CS-25 AMENDMENT 14 — CHANGE INFORMATION

The Agency publishes amendments to Certification Specifications as consolidated documents. These documents are used for establishing the certification basis for applications made after the date of entry into force of the amendment.

Consequently, except for the note 'Amdt 25/14' under the amended paragraph, the consolidated text of CS-25 does not allow readers to see the detailed changes introduced by the new amendment. To allow readers to also see these detailed changes this document has been created. The same format as for the publication of Notices of Proposed Amendments (NPAs) has been used to show the changes:

Figure 1 – Tyre Debris Threats

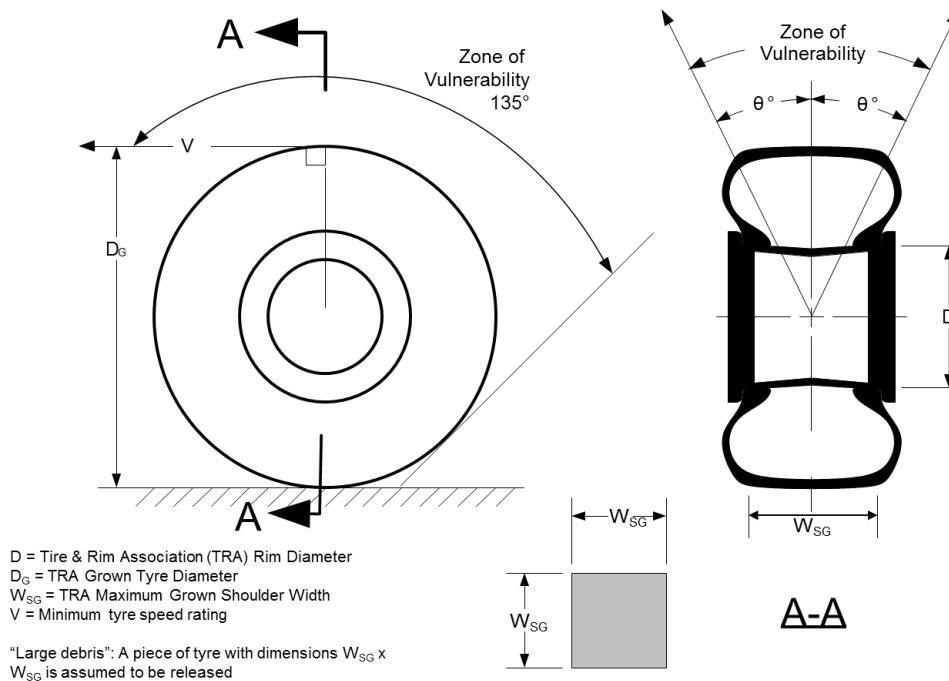
These debris are assumed to be released from the tread area of the tyre and projected towards the aircraft within the zones of vulnerability identified in Figure 1:

- (i) a 'large debris' with dimensions $W_{SG} \times W_{SG}$ at D_G and a thickness of the full tread plus outermost ply (i.e. the reinforcement or protector ply). The angle of vulnerability θ is 15° .
- (ii) a 'small debris' consisting of 1 per cent of the total tyre mass, with an impact load distributed over an area equal to 1.5 per cent of the total tread area. The angle of vulnerability θ is 30° .

The debris have a speed equivalent to the minimum tyre speed rating certified for the aircraft (the additional velocity component due to the release of carcass pressure need not be taken into account).

Figure 2 - Wheel Flange Release Threat

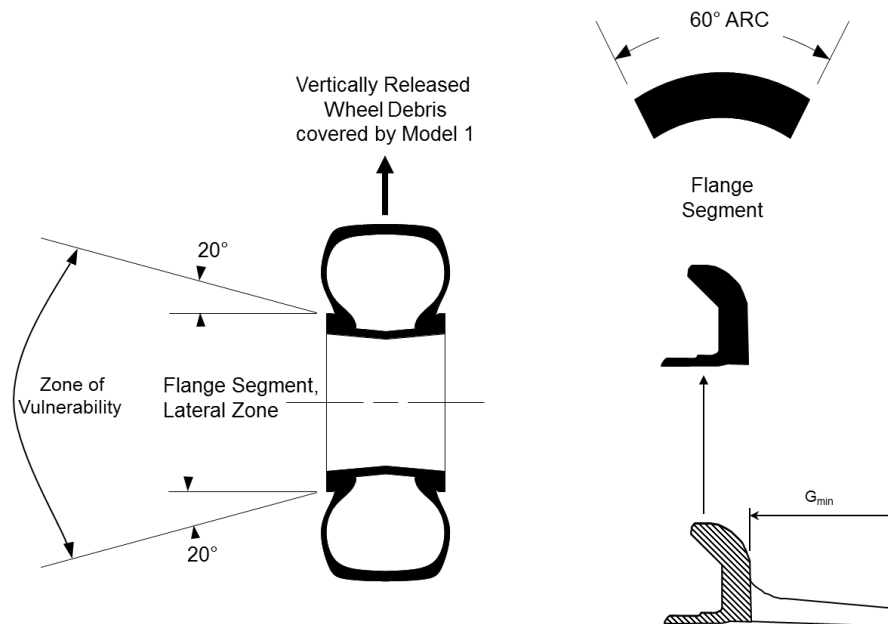
(1) It is considered that a 60° arc segment of the wheel flange can be released laterally, in the zones identified in Figure 2. The speed of release is 100 m/s (328 ft/s).

Where multiple wheels are installed on a landing gear leg, the lateral release of only the flange on the outer wheel halves needs to be considered.

If only a single wheel is installed on a landing gear leg, then the lateral release of either flange shall be considered.

Figure 3 – Flailing Tyre Strip Threat

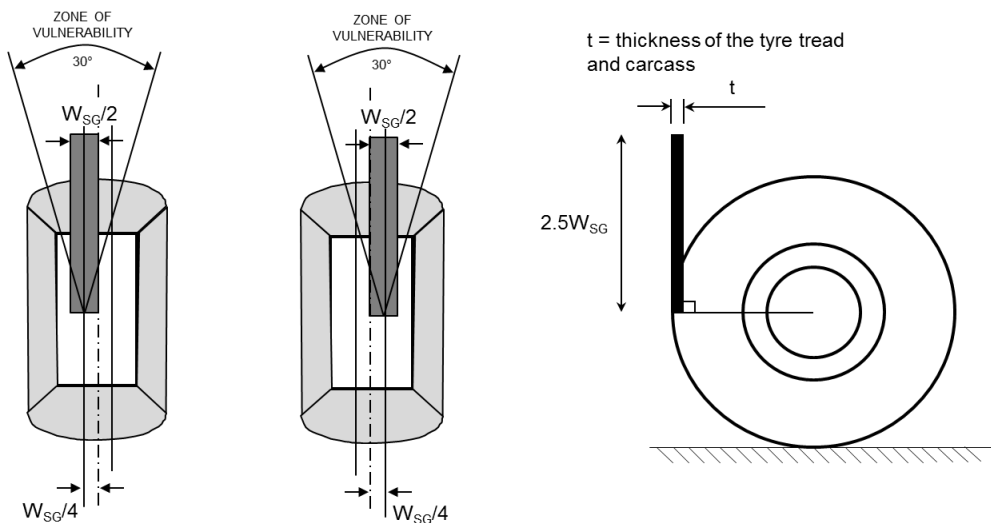
A flailing tyre strip with a length of $2.5 W_{SG}$ and a width of $W_{SG}/2$ will remain attached to the outside diameter of the rotating tyre at take-off speeds.

The thickness (t) of the loose strip of tyre is the full tread plus the carcass of the tyre. If the applicant demonstrates that the carcass will not fail, then the thickness may be reduced to full tread plus outermost ply (i.e. the reinforcement or protector ply).

The strip has a speed equivalent to the minimum tyre speed rating certified for the aircraft. For this threat the zone of vulnerability is 30° , as shown in Figure 3.

The strip has an initial speed equivalent to the minimum tyre speed rating certified for the aircraft. Allowance for rotation speed reduction during retraction may be substantiated by the applicant. For this threat the zone of vulnerability is 30° , as shown in Figure 3.

Figure 4a – Tyre Burst Pressure Effect – Bias Tyre

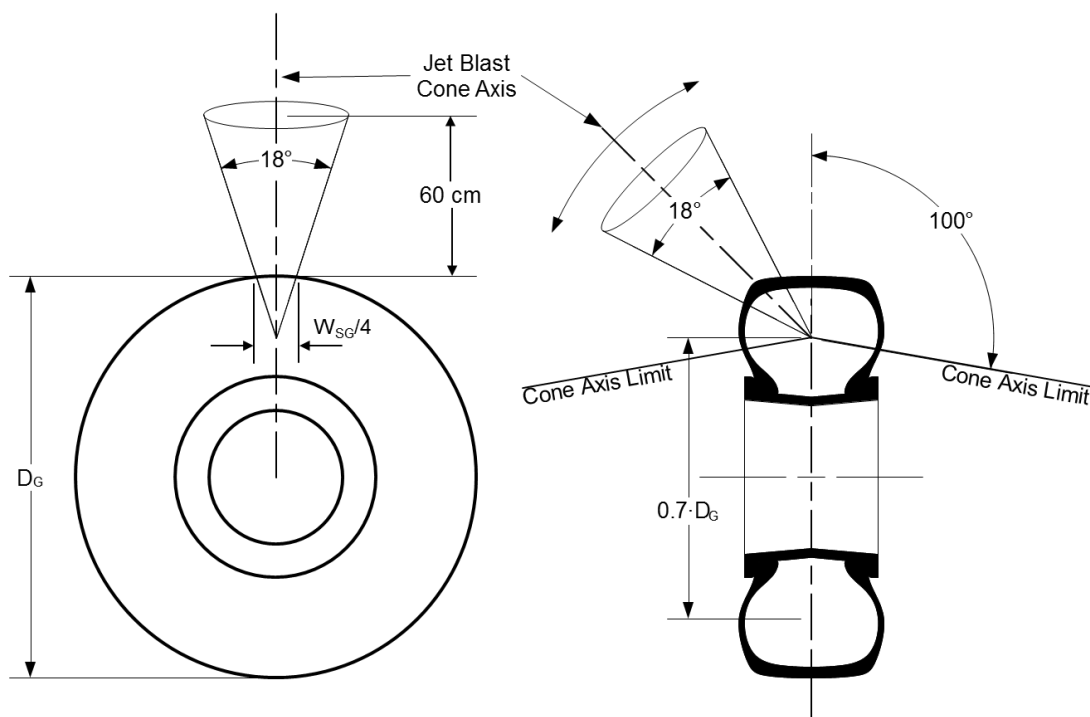
4) For bias tyres, the burst plume model shown in Figures 4a and 4b should be used, with the blast cone axis rotated over the tread surface of the tyre ($\pm 100^\circ$ as shown in Figure 4a). The pressure distribution is provided in Figures 4b and 4c.

Figure 4e – Tyre Burst Pressure Effect – Radial Tyre

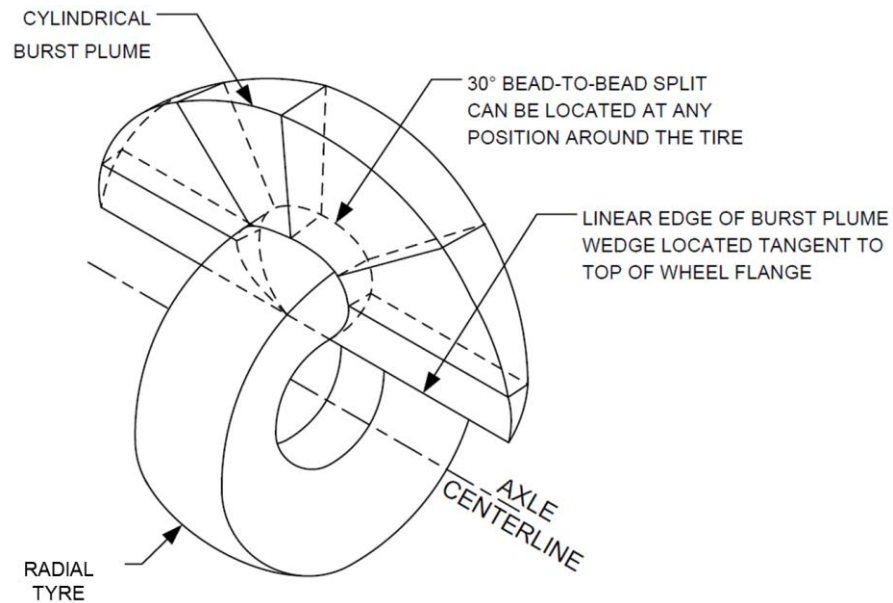
5) For radial tyres, the burst plume model ('wedge' shape) is shown in Figures 4d and 4e. The pressure decay formula provided in Figure 4e below should be used. It provides the level of pressure as a function of the distance from the tyre burst surface.

Figure 1 — Cube impact angles

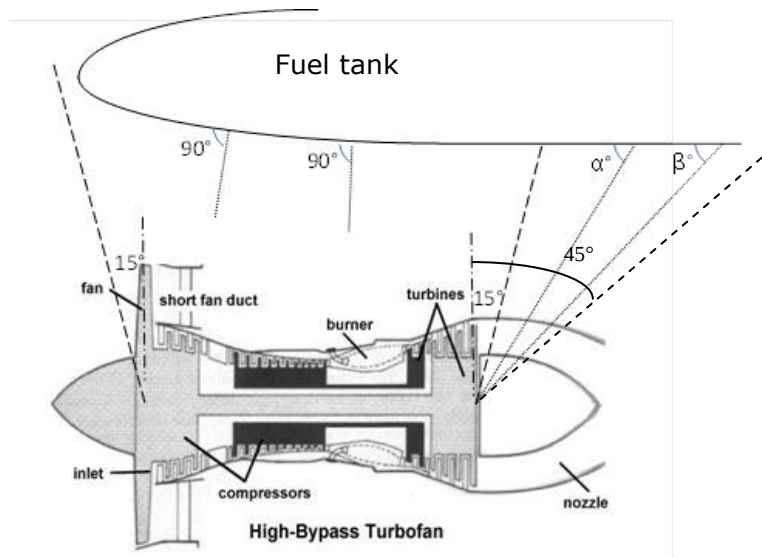
Within this area, the angle of impact (see Figure 1, α and β angles) is defined by the trajectory of the debris originating from the centre of rotation of the rearmost engine turbine plane.

Note: α and β angles are examples of possible angles between the fuel tank skin and the debris trajectory at the impact.

Figure 2 — Example of the ± 15 -degree threat area representation

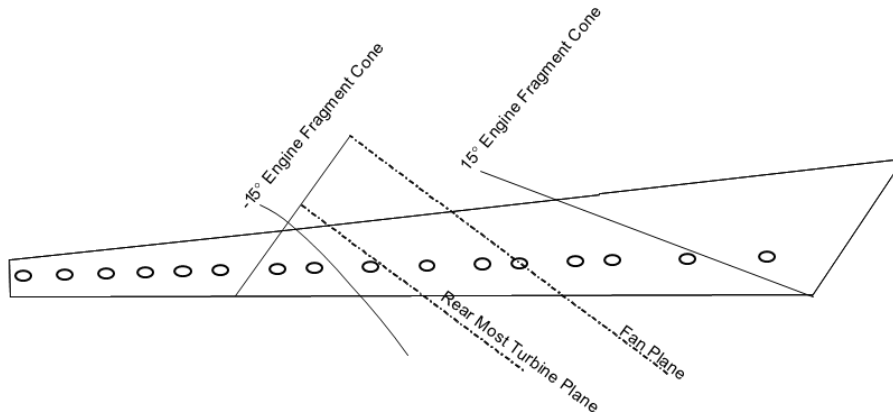
Within 15 degrees forward of the fan plane (or front engine compressor if no fan) measured from the centre of rotation to 15 degrees aft of the rearmost engine turbine plane measured from the centre of rotation, a normal impact is used (i.e. the angle between the trajectory of the debris and the surface is 90 degrees).

Note: The threat area between -15 and -45 degrees is not represented.
